Re: **Investigation Workplan Addendum**
Chevron Service Station #9-0917
5280 Hopyard Road
Pleasanton, California
Fuel Leak Case #RO439

Subject: Fuel Leak Case No. RO0000439, Chevron #9-0917, 5280 Hopyard Road, Pleasanton, CA – Work Plan

FIGURE
2

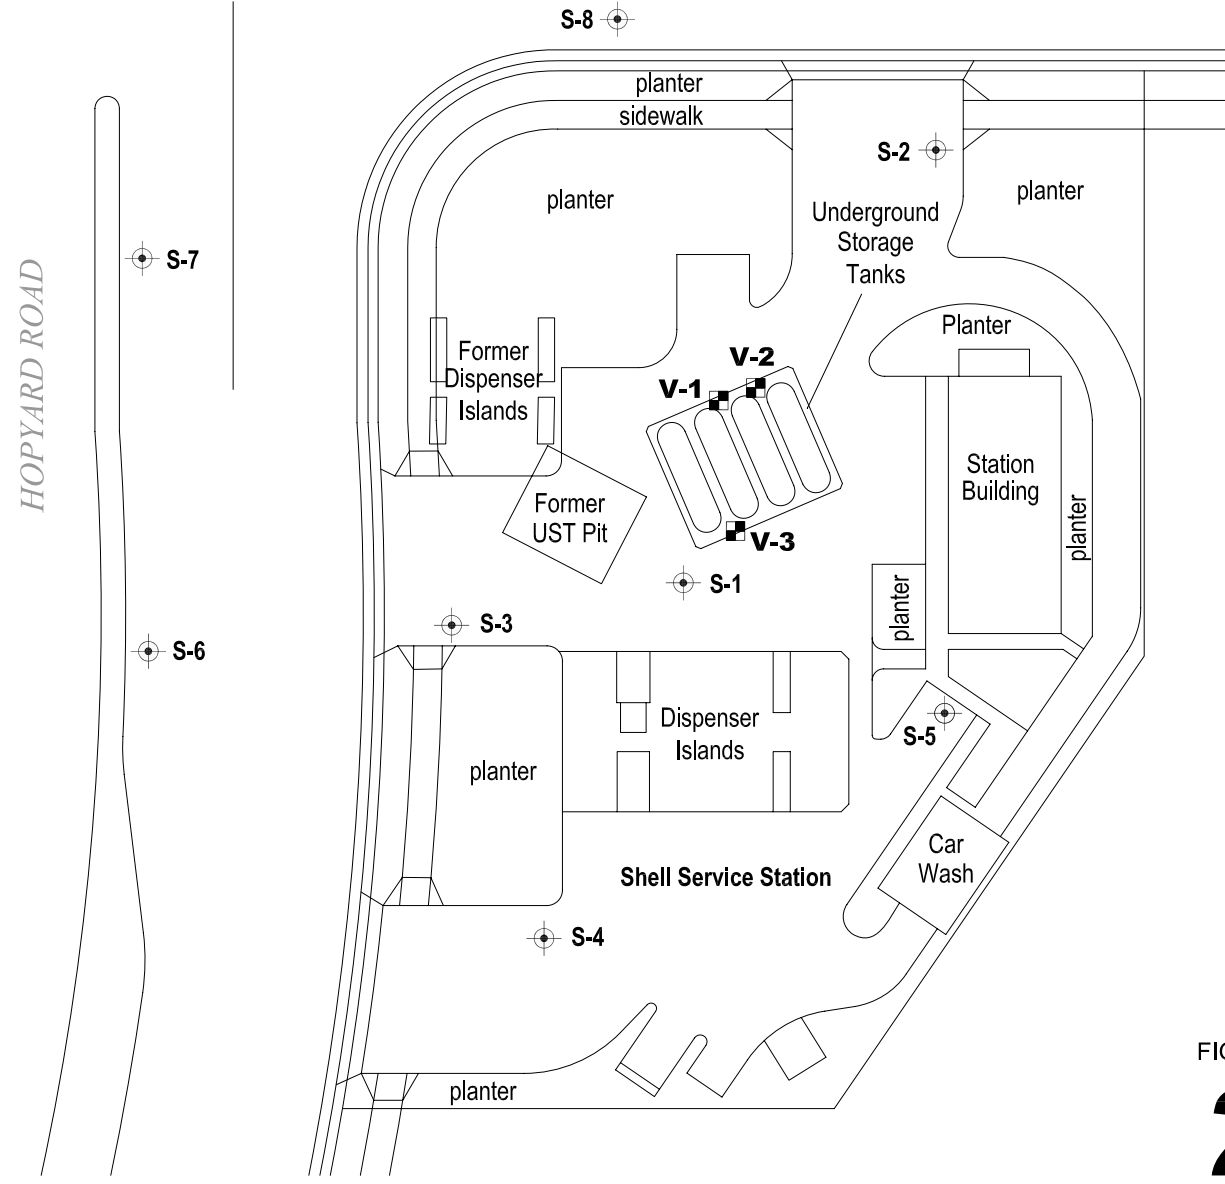
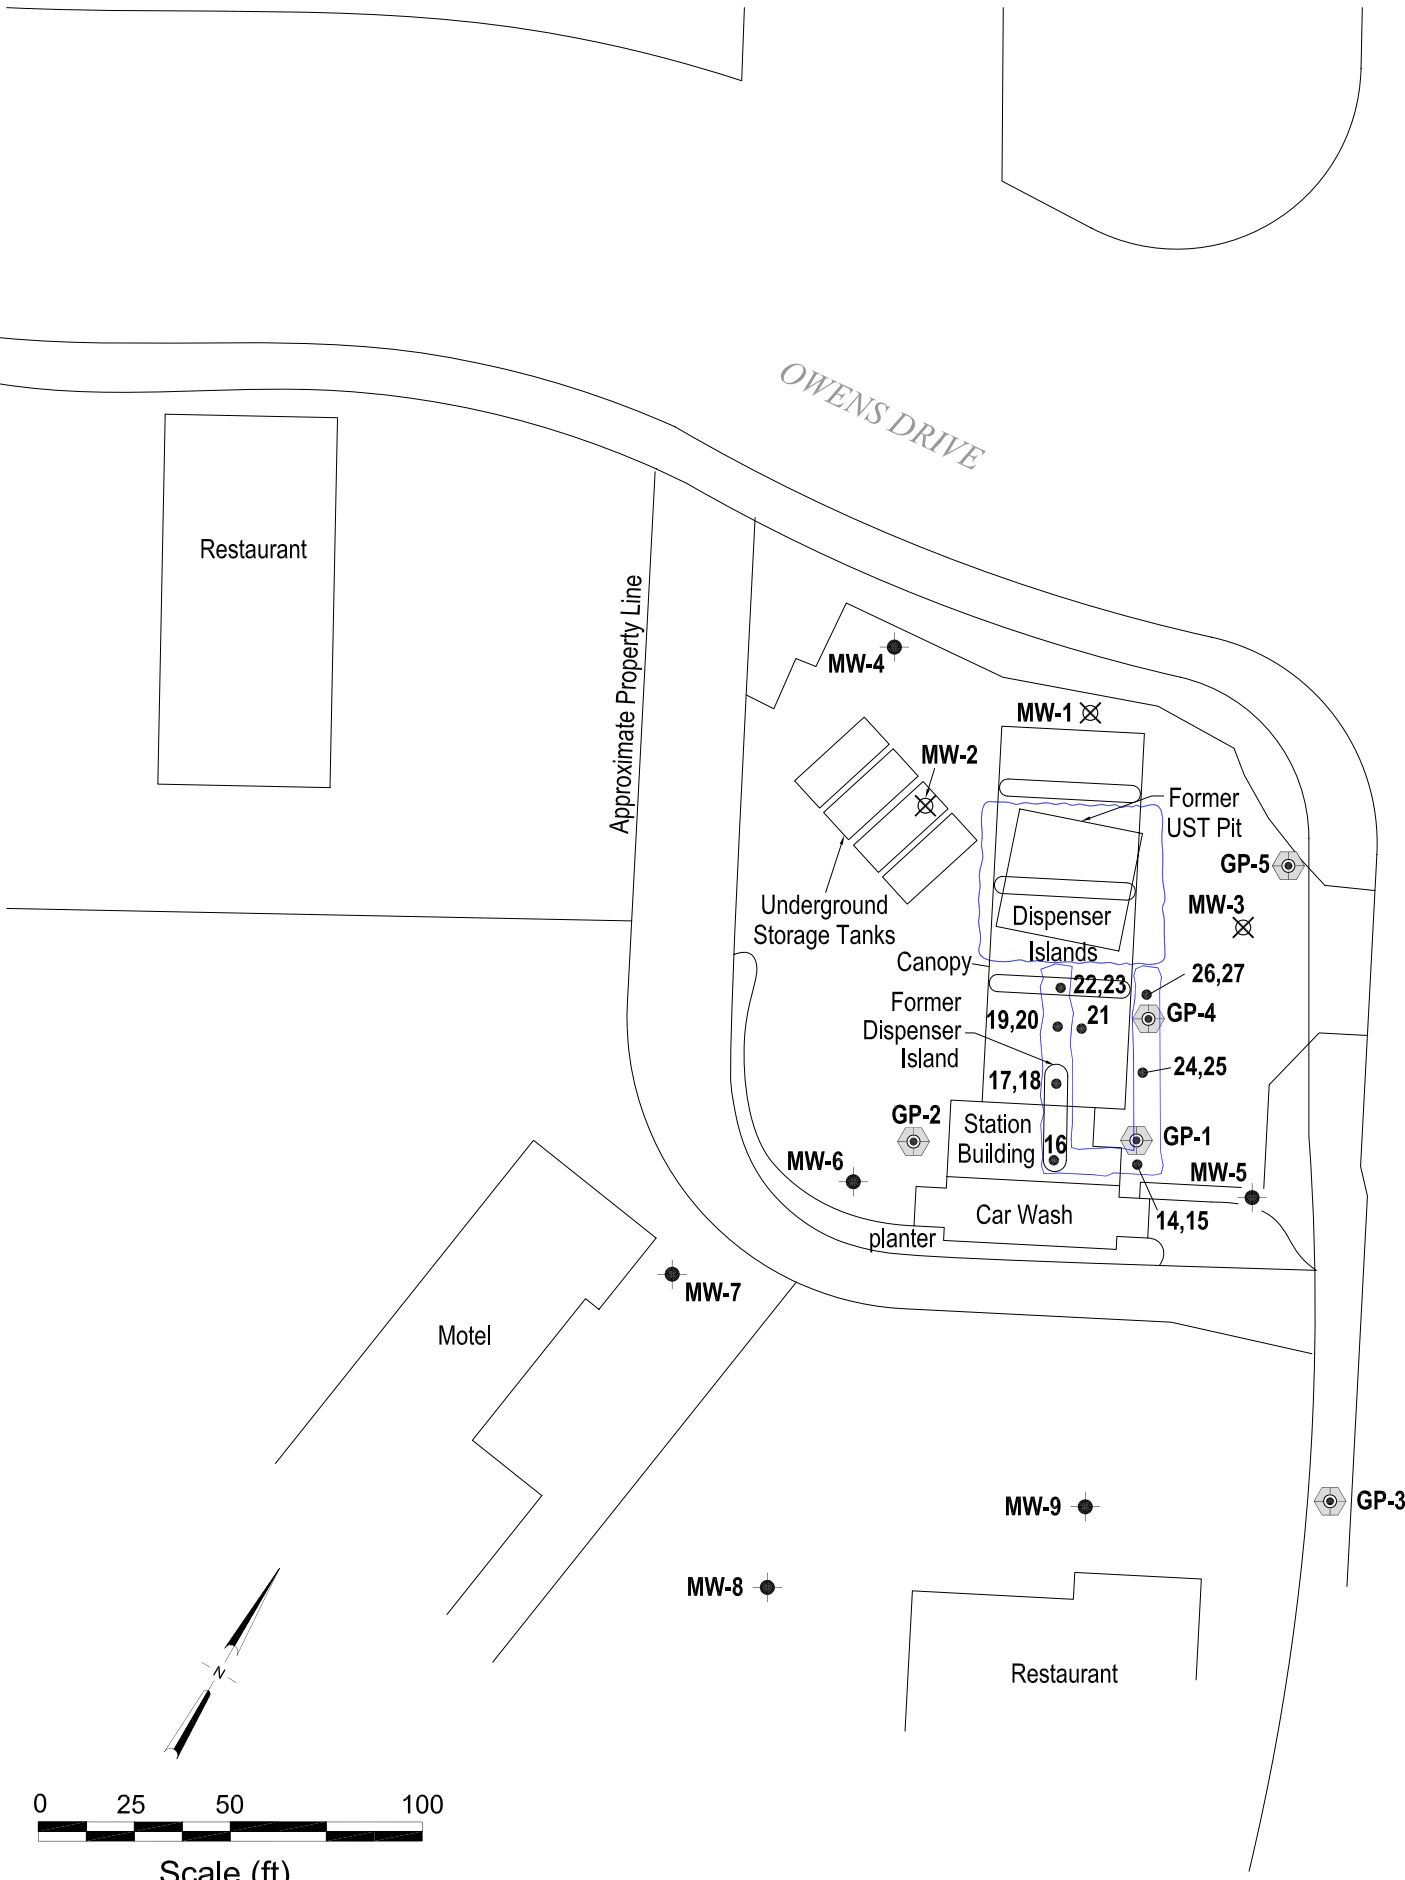
1. **Proposed Sampling Locations.** We concur with the proposed sampling locations for borings GP-1, GP-2, and GP-3. However, we request that one additional boring be advanced north of GP-1 along the eastern side of the former piping trench and one additional boring be advanced on the western side of the station building. We request that proposed boring GP-1 and the additional requested boring on the western side of the station building be extended to a sufficient depth to assess whether petroleum hydrocarbons have affected a lower water-bearing zone. Please incorporate this expanded scope of work in the revised Work Plan requested below.

To further define the lateral and vertical extent of hydrocarbons in groundwater and assess on-site human health risk, Cambria proposes advancing five soil borings, GP-1 through GP-5 (Figure 2). In accordance with the technical comments from the Alameda County Environmental Health, Cambria proposes that borings GP-1 and GP-2 be advanced into deeper water-bearing zones approximately 45 fbg to 60 fbg. Additionally Cambria proposes completing a conduit study to determine any potential pathways for hydrocarbon migration.

Soil Borings: All soil borings will be cleared to 10 fbg by hand auger. GP-1 and GP-2 will be advanced to approximately 60 fbg using Cone Penetration Technology (CPT) direct push rig. Borings GP-3 through GP-5 will be advanced five feet below first encountered groundwater, or approximately 15 fbg, using a direct push rig. Soil samples from GP-1 and GP-2 will be collected for chemical analyses at 3 fbg, 5 fbg, and 10 fbg. Soil samples from GP-3 through GP-5 will be collected for chemical analyses at 5 fbg and 10 fbg. Upon completion of each boring, the borings will be grouted to surface with neat Portland cement.
